**DOCUMENT 00 90 00**  
**ADDENDUM**

**ADDENDUM No.:** 1

**DATE:** May 4, 2023

**RE:** NORTHWOOD TECHNICAL COLLEGE  
NEW RICHMOND EXTERIOR IMPROVEMENTS  
1019 SOUTH KNOWLES AVENUE  
NEW RICHMOND, WISCONSIN 54017  
PROJECT NO. 23016

# 1 POWER EQUIPMENT CENTER WORKING PLANS

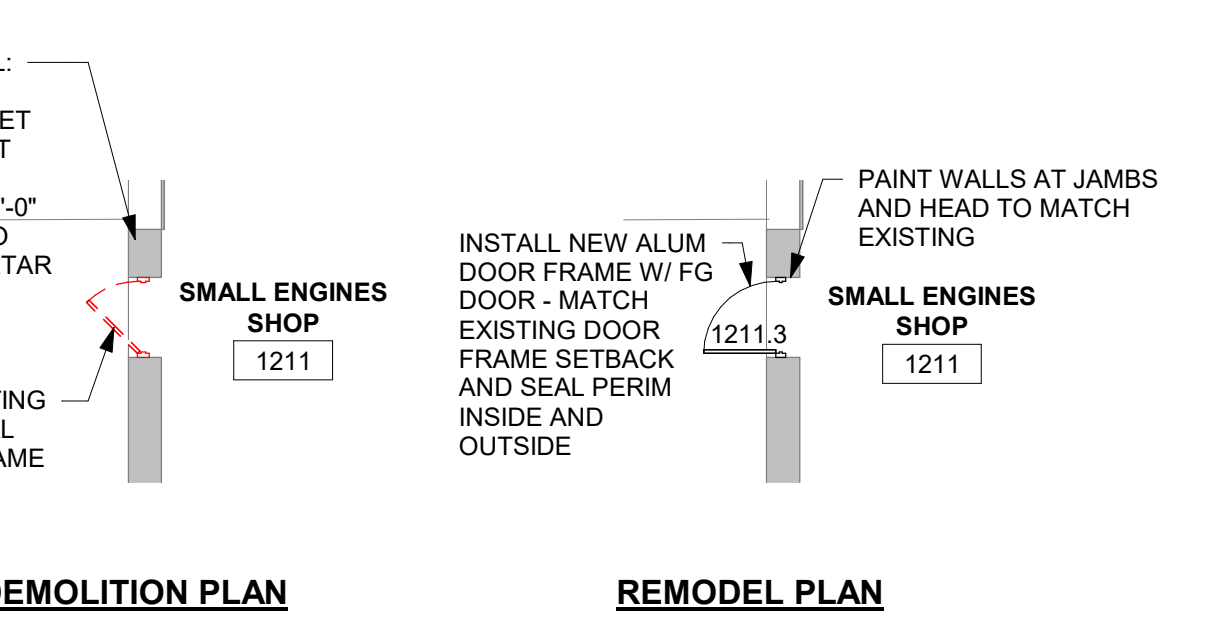
4. Sheet A101 WORKING PLANS AND DOOR SCHEDULE 30"x42"
  - a. See the revised sheet included in this addendum. Disregard the previous version.
  - b. See clouded changes and details 1 & 10 related to coordinating with Owner's security consultant for disconnection and reconnection of electrical items.
  - c. See clouded changes at door schedule remarks items 3, 4, & 5.
